ADDENDUM NO. 1

CITY OF ROLLA
TAXIWAY A RECONSTRUCTION AND TAXIWAY CONNECTOR REHABILITATION
at
ROLLA NATIONAL AIRPORT (VIH)
VICHY, MO

MoDOT Project # 23-056A-1

ADDENDUM NO. 1

GRADING AND SPOT ELEVATION PLAN
TAXIWAY A (STA. 05+00 - 10+00)

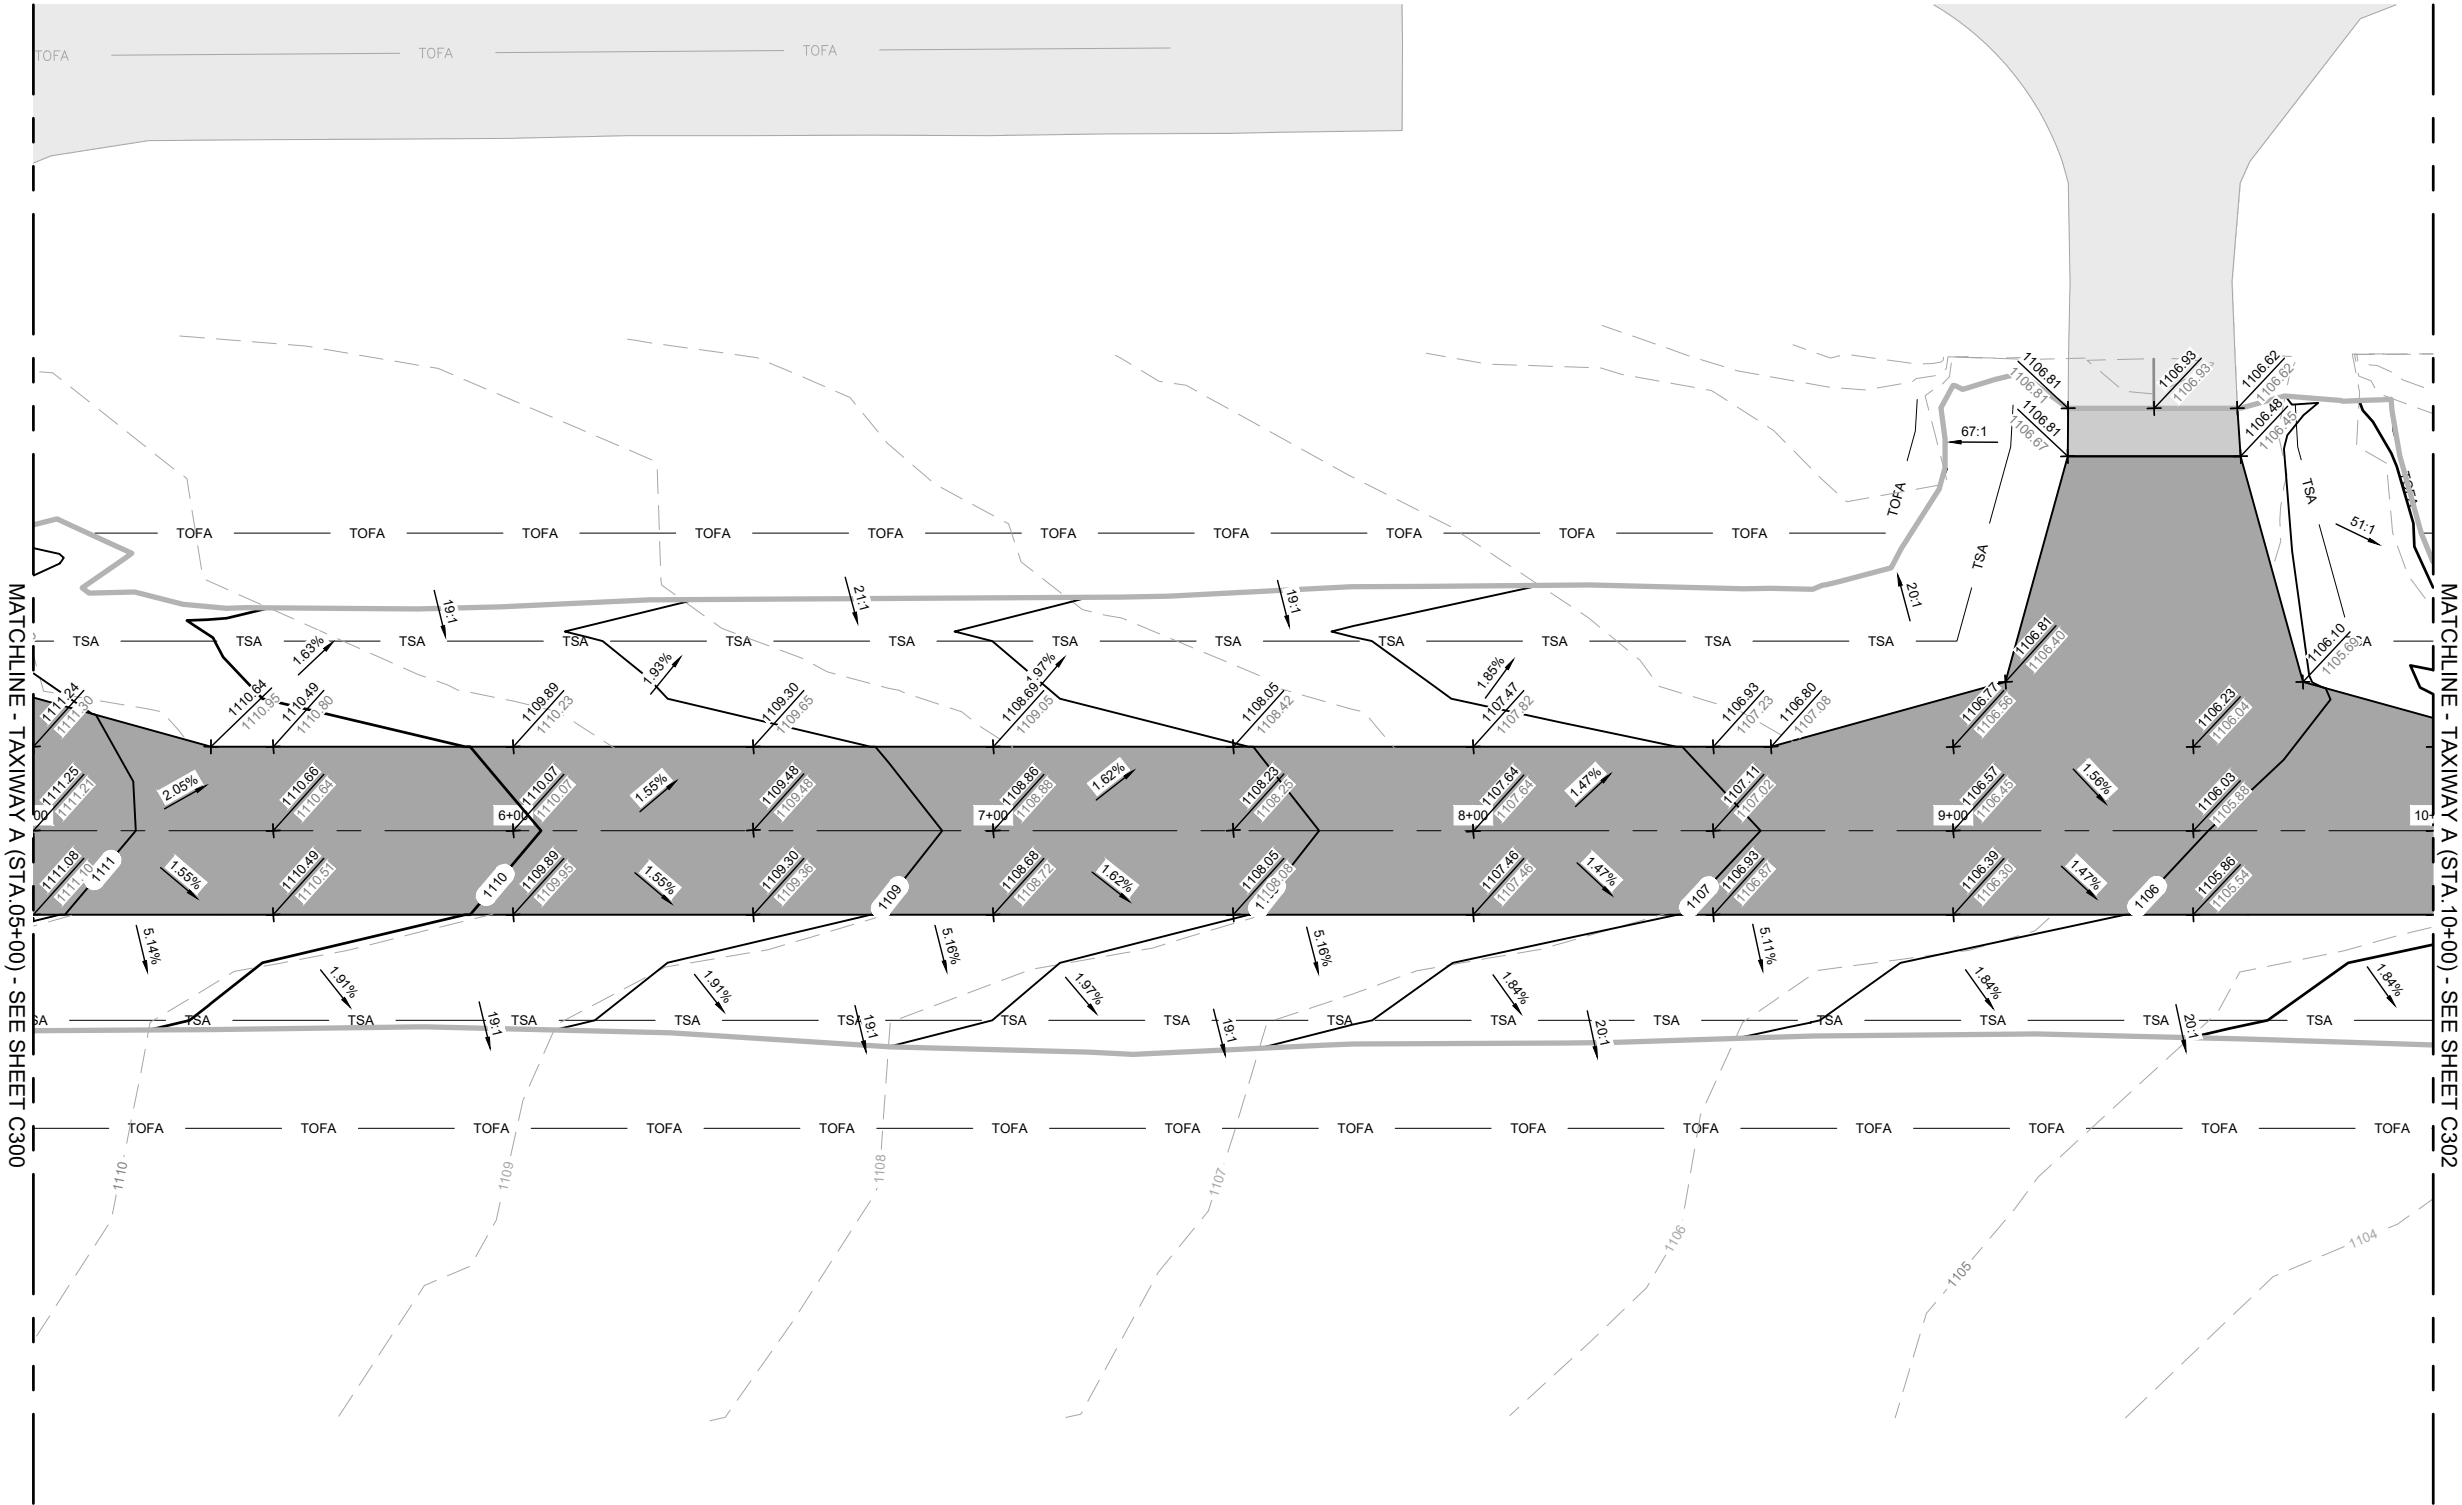
Revision: Added spot elevations every 50 feet.

SHEET NAME C401
SHEET NO. 33 of 54

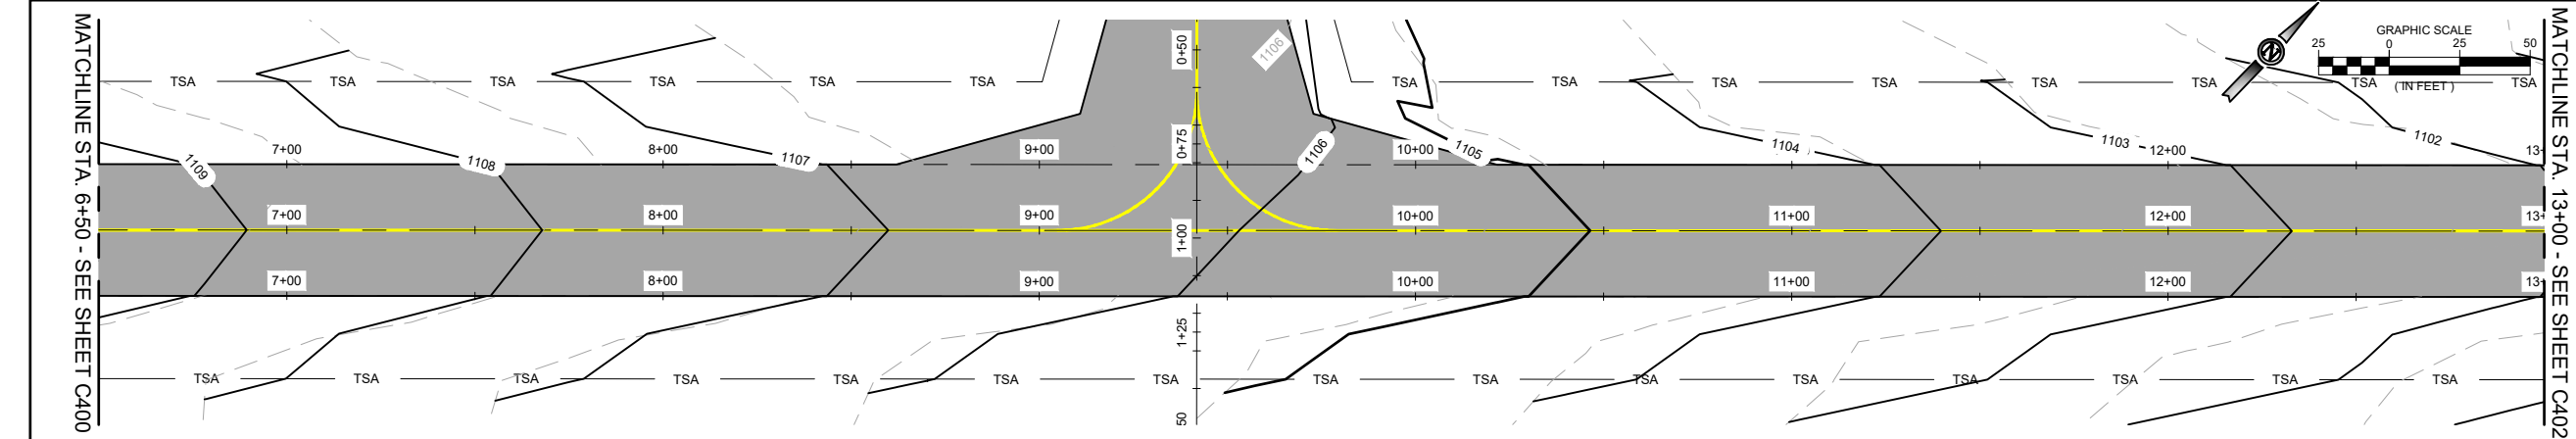
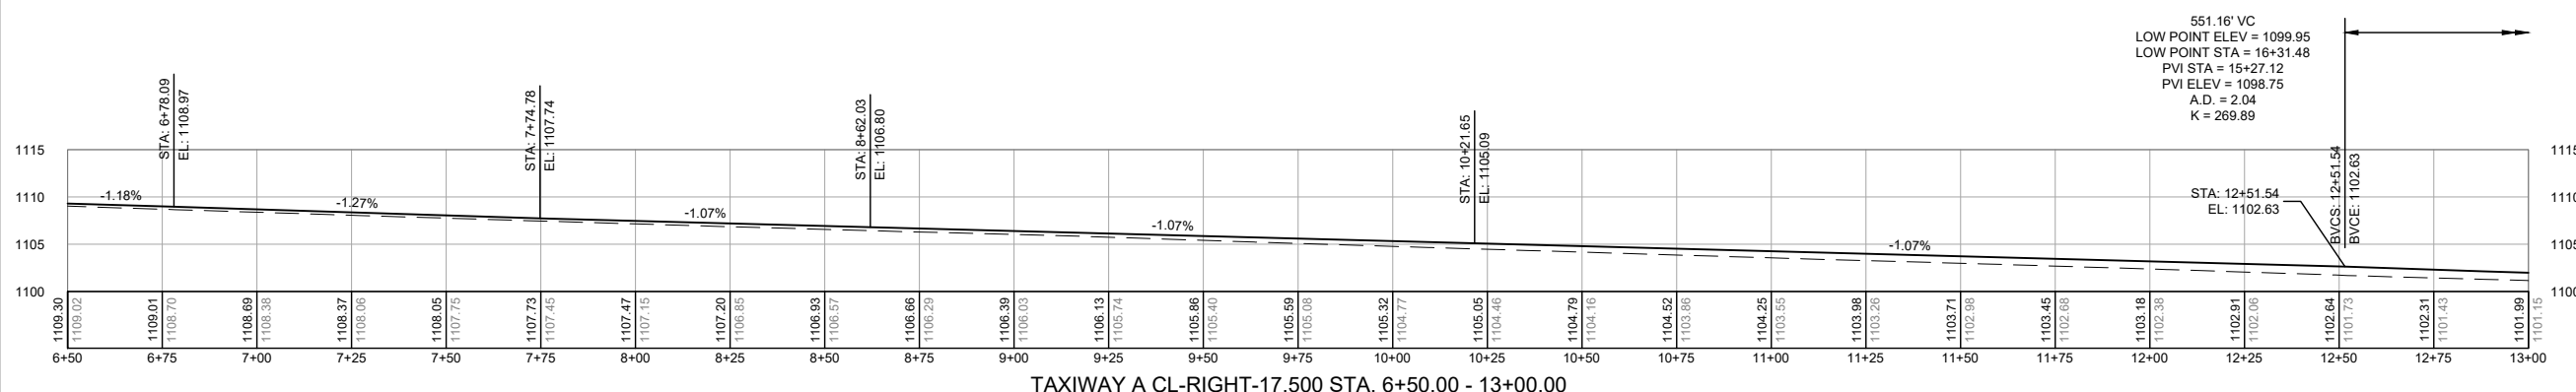
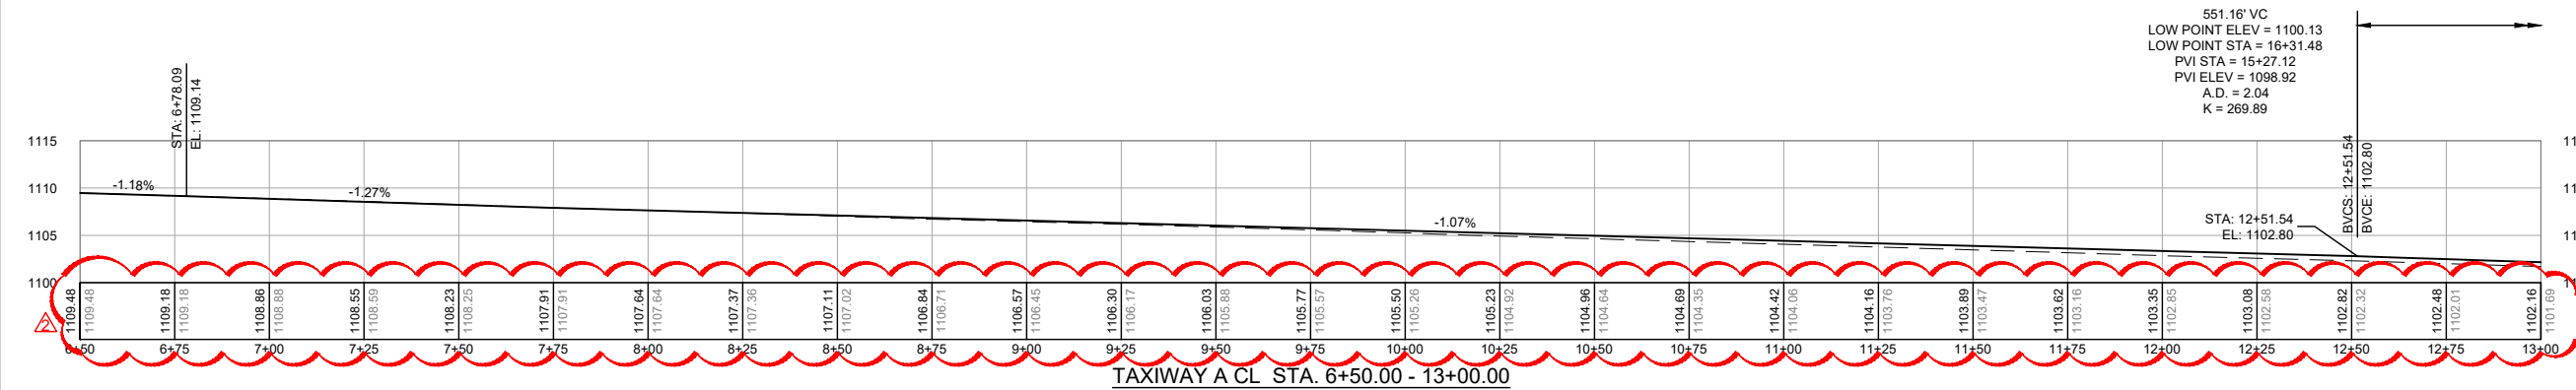
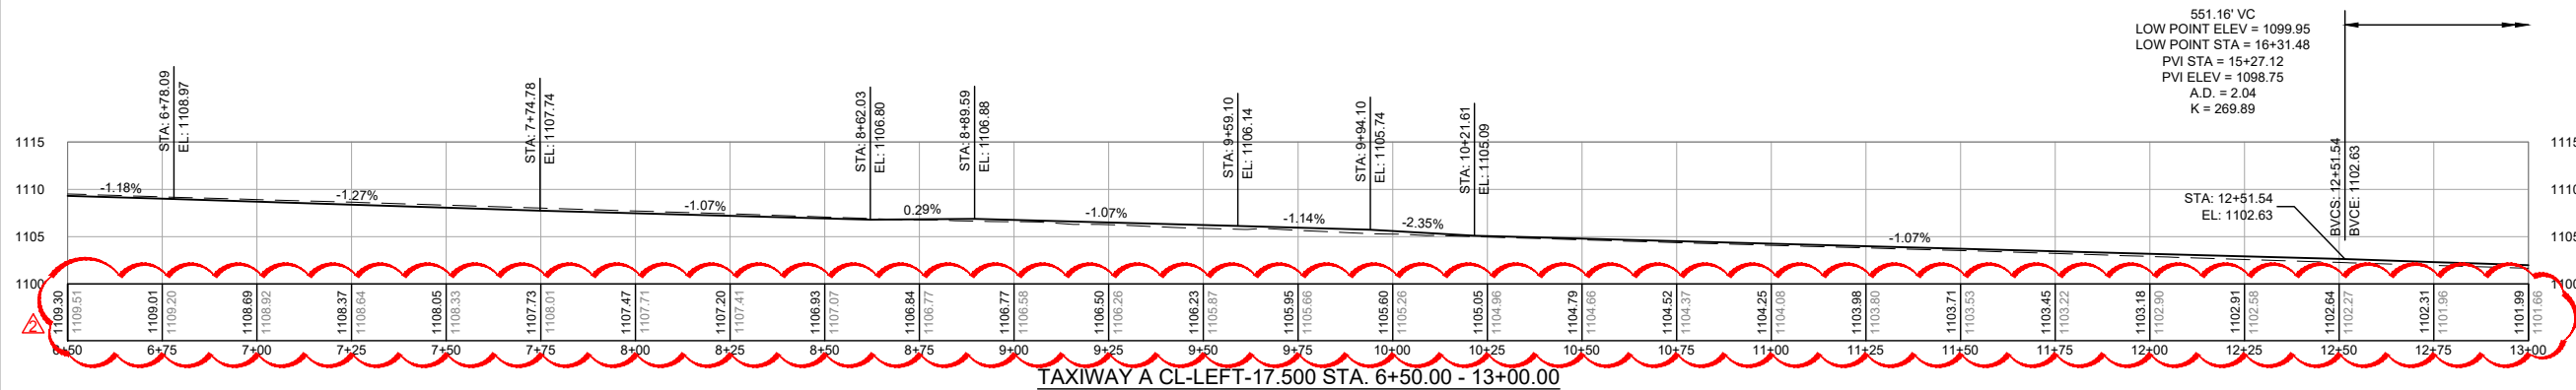
Revision: Added existing and proposed grade labels to profile stationing.
